RE: Permit No. M-1980-244; Cripple Creek & Victor Gold Mining Company; Cresson Project; Preliminary Adequacy Review Response to Technical Revision 130 – Stormwater Improvements

On February 11, 2022, Newmont Corporation's Cripple Creek and Victor Gold Mining Company (CC&V) received the Division of Reclamation, Mining, and Safety (DRMS) adequacy review of Technical Revision (TR) 130 to Permit M-1980-244, proposing improvements to stormwater controls. Below are DRMS comments in **bold** followed by CC&V's responses in *italics*.

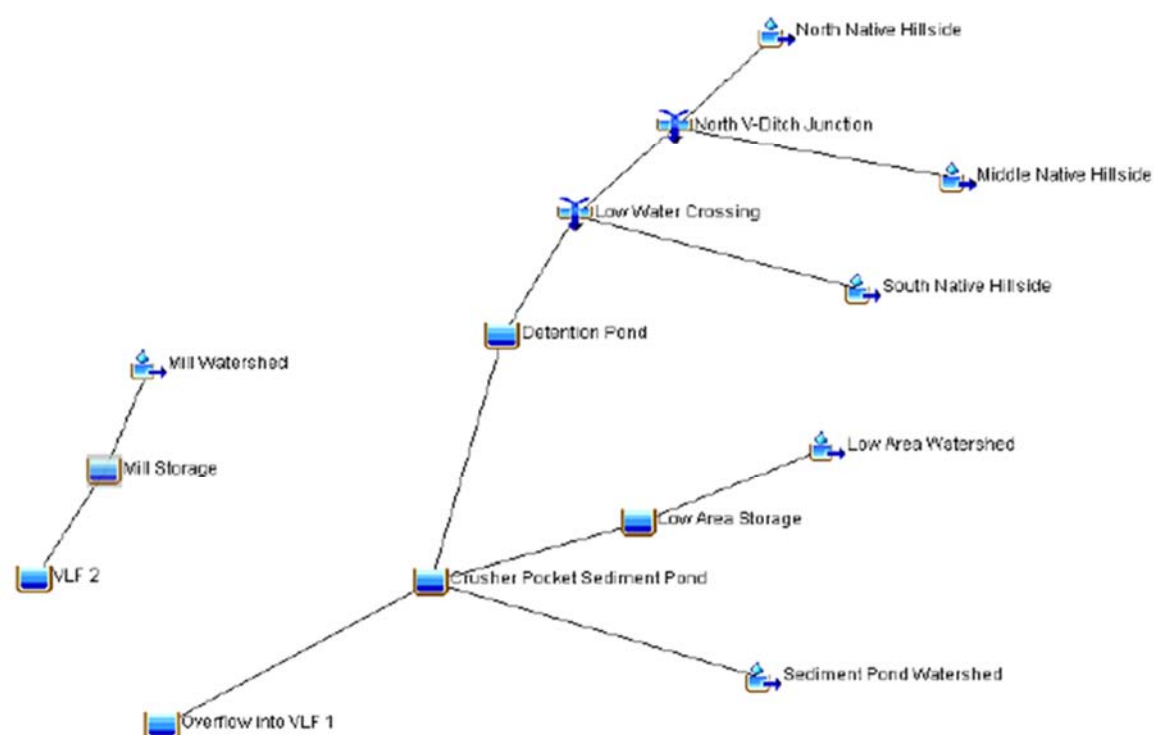
- 4) **Times of concentration:** The three "Native Hillside" watersheds use the maximum 300 feet for sheet flow. Steep slopes accelerate sheet flow and heavily treed or rocky slopes tend to deflect sheet flow more quickly to the faster, shallow concentrated flow, thereby decreasing the time of concentration and increasing the estimated peak flow. Common practice for calculating times of concentration for steep, heavily treed or rocky slopes would limit the sheet flow to no more than 100 feet. Please make appropriate corrections.

The time of concentration calculations and corresponding lag times used in the HEC-HMS model were modified to include a 100 ft sheet flow length. The table below reflects modified inputs and results from the HEC-HMS model, and the schematic shows the HEC-HMS model layout.

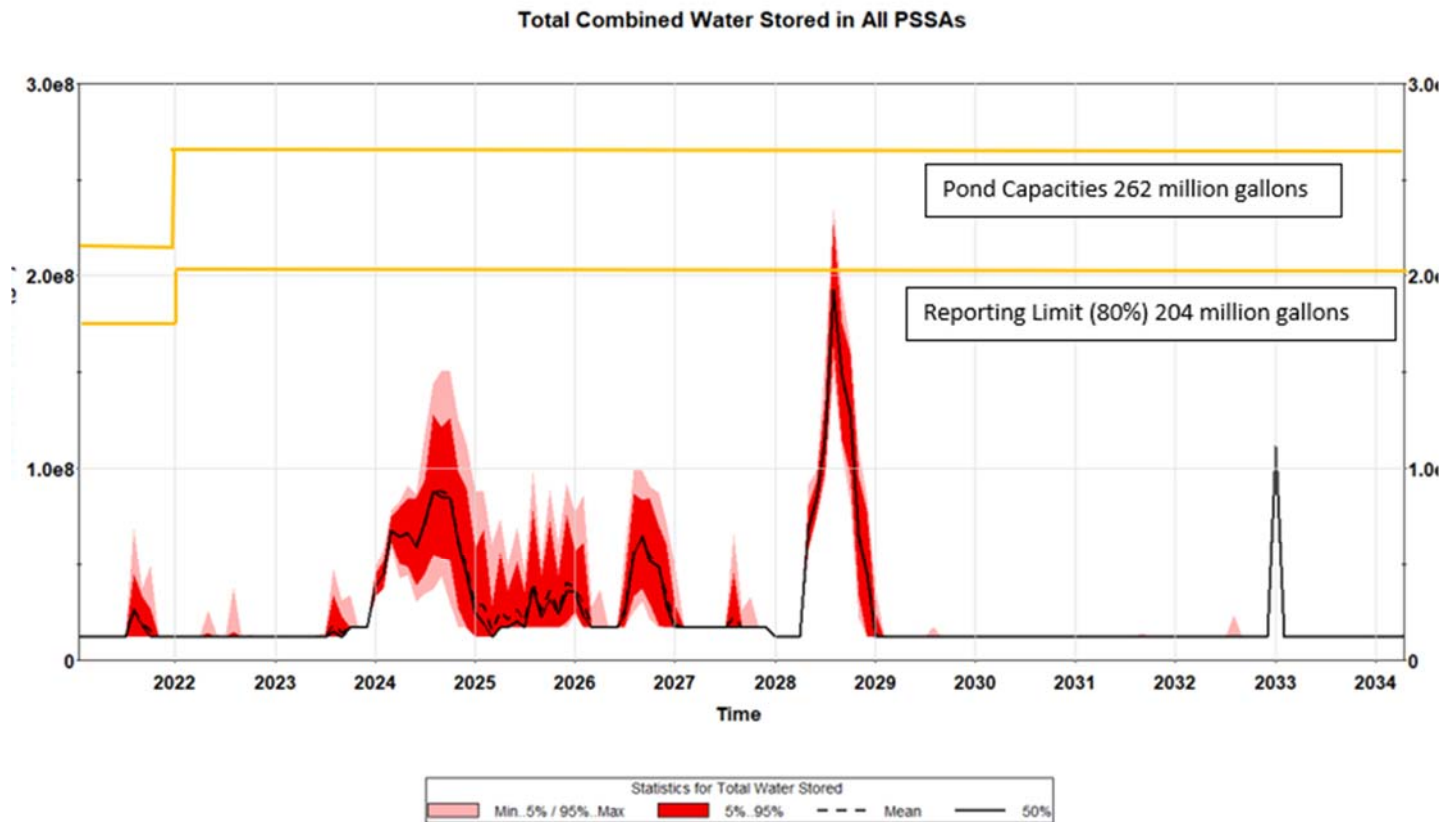
9) Water balance: It is difficult to interpret the graphs in Attachment B, but it appears the 95 percent confidence is exceeded in late 2024 and most of 2027. Please provide additional narrative and/or labels on the two graphs to explain how the proposed discharge to VLF2 will not exceed the 80 percent full requirements for VLF2.

Although the graphs originally included with TR130 showed exceedances in 2024 and 2027 for the VLF2 Phase 1/2 PSSA, sufficient capacity exists in combined VLF PSSAs at site, as shown in the graph below. The water balance model originally showed excess water in the combined PSSAs (exceeding the 80 percent full reporting action level) during 2027 due to a decreased solution application rate (leaching VLF2 Phase 3 only) and continued solution draindown from VLF2 Phase 1/2. The graph shown below reflects a potential adjustment in operational solution management in 2027 and 2028 to show how excess water in the PSSAs can be managed with minor operational adjustments. The graph below reflects leaching VLF2 Phase 3 according to the planned rate and stacking plan, then recirculating a small portion of solution onto the VLF2 Phase 1/2 heap to maintain required freeboard in the combined PSSAs. The modeled spike in 2028 reflects a condition where the heap height is low, causing a more rapid draindown time. Again, this spike can be mitigated by recirculating solution elsewhere on VLF2 (or implementing other operational water management strategies) to ensure sufficient freeboard is maintained in the PSSAs.

This scenario included with the graph below is intended to provide an example of potential operational adjustments that can be implemented to maintain required freeboard levels only; other methods may include modifying ore stacking plans, re-applying leach solution to VLF2 Phase 1/2 ore at a different rate, or other process-related operational strategies that will prevent exceeding the 80 percent full reporting action level. CC&V intends to actively monitor the VLF2 PSSAs during operations to maintain freeboard levels.

The 80 percent full reporting action level, including the additional capacity after the VLF2 Phase 3 PSSA estimated certification date, has been included on the graph for reference.

FIGURE NO. 1

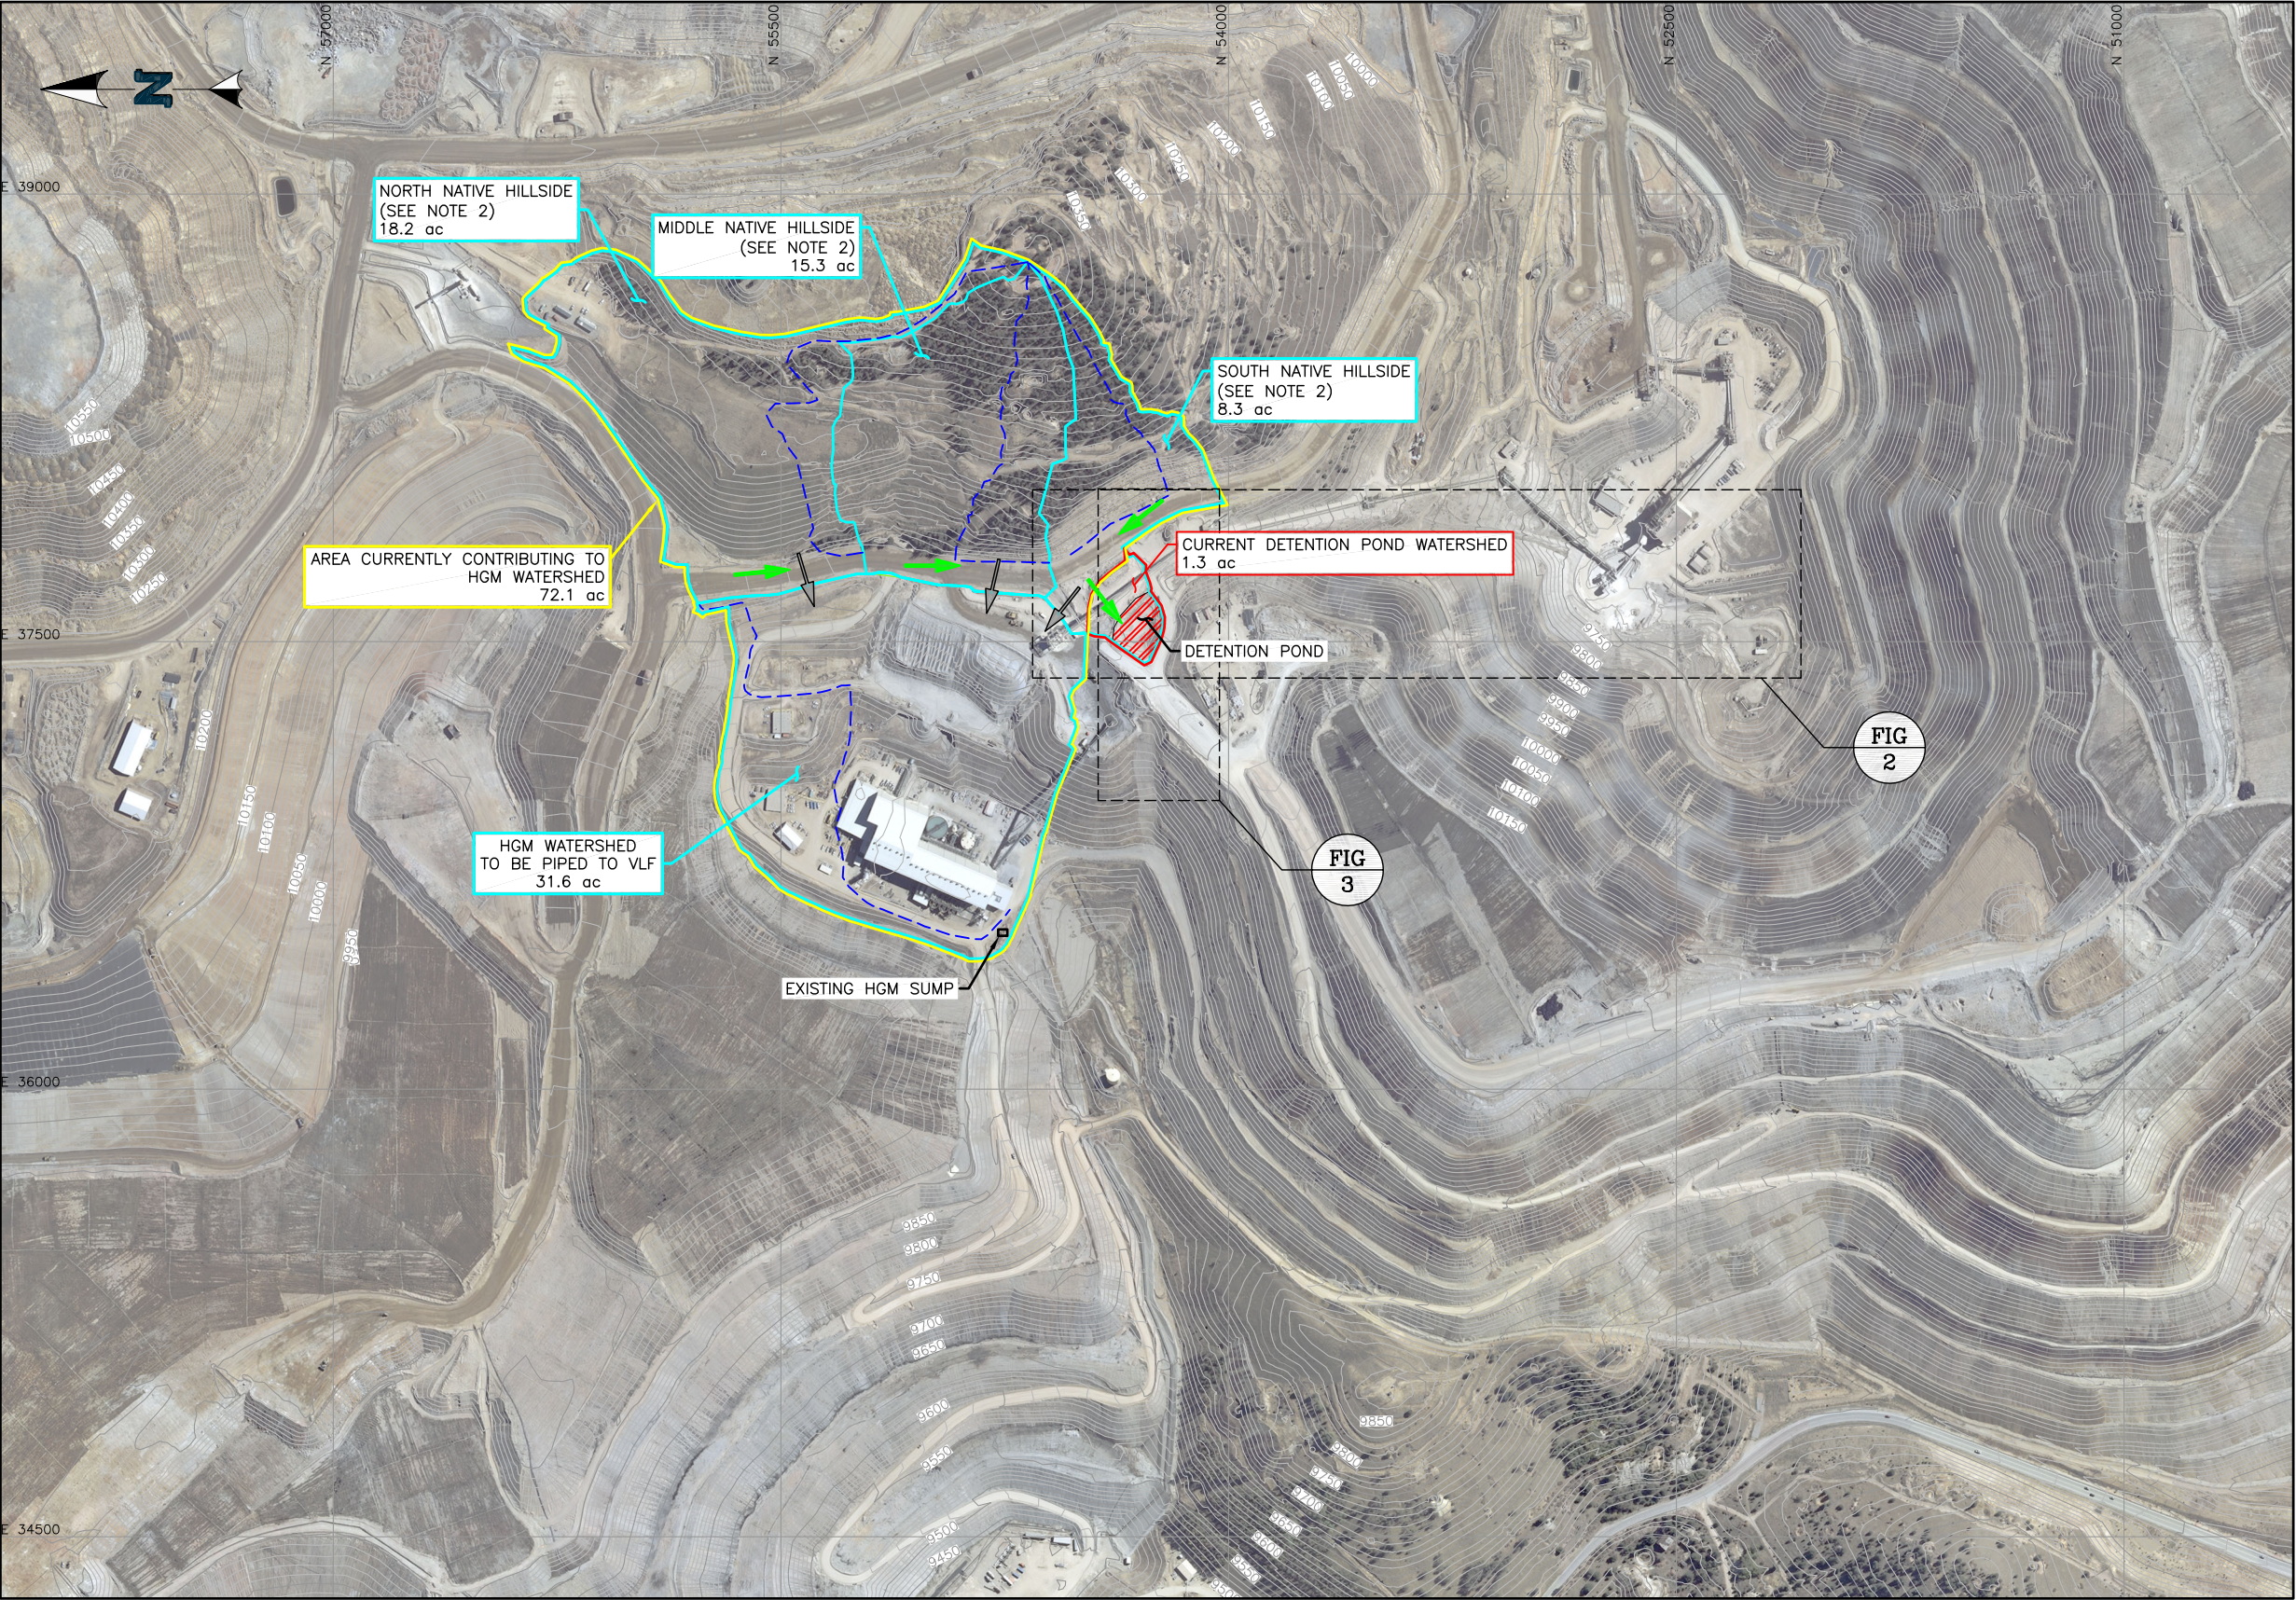
- 1) **Purpose:** The compliance problem #2 cited in the August 10, 2021 DRMS inspection report was directed toward stormwater controls at the High Grade Mill (HGM) and the area off of the Valley Leach Facility 1 liner. The specific requirement was "to describe or identify how the Operator intends to safely control impacted stormwater intercepted by the High Grade Mill liner." TR130 focuses the crusher area (which has no impact on stormwater at the HGM) and on the area east of the HGM. No designs or analyses are presented in TR130 demonstrating how existing or improved stormwater controls are going to effectively control stormwater intercepted by the HGM. Please provide analyses and designs demonstrating how stormwater intercepted by the HGM will be controlled, including routing of stormwater captured in the HGM area and routed to the VLF2 and/or the low area south of the HGM and north of VLF1 (hand labeled as "New Sump" on Drawing No. 30-647-501 in the TR-79 submittal). Discharge flows from the New Sump area are what caused the problem resulting in contact water being discharged off lined areas, and the erosion of DCF off the VLF2 liner. Furthermore, if stormwater routing controls are not designed and constructed to convey discharges from the "New Sump" area, then the New Sump needs to be a zero-discharge facility. No analyses are presented for the New Sump area. Please provide analyses and designs demonstrating the remaining runoff to the New Sump area, accounting for the reduction in flow from the proposed improvements hydrologic analyses for the New Sump area should include runoff from the north slope of VLF1, as this slope has not been ripped for probably more than 20 years and would be expected to shed some runoff during a high intensity storm event (reflected in the use of CN = 91 for the crusher area watersheds).

The August 2021 incident was primarily caused by surface water runoff from the native area to the east and the adjacent haul road running onto the HGM platform, overtopping the existing High Grade Mill (HGM) concrete sump, and flowing into the “New Sump” area outlined in TR79. Sediment accumulation at the “New Sump” prevented water from efficiently infiltrating into the Valley Leach Facility 1 (VLF1) drain cover fill (DCF), causing water to pond and ultimately wash out portions of the VLF1 perimeter berm. Figure 1 shows the locations of the HGM sump and the “New Sump” for clarity.

- 1. Reduce the volume of impacted water by diverting surface water runoff from the eastern native hillside and haul road away from the HGM area. Currently, the watershed area reporting to the HGM liner is 72.1 acres (ac). By diverting flows from the eastern native hillside and haul road as proposed, the HGM watershed area will be reduced to 31.6 ac. Figure 1 shows the existing HGM liner watershed as a yellow line (72.1 ac), and the reduced watershed from the proposed activities described in TR130 shown as a cyan line (31.6 ac). Approximately 40.5 ac of native area will be routed away from the HGM watershed and ultimately to EMP-11 via the “detention pond” (original watershed comprised 1.3 ac of the reported 41.8 ac of native area) and new proposed conveyance pipeline.*
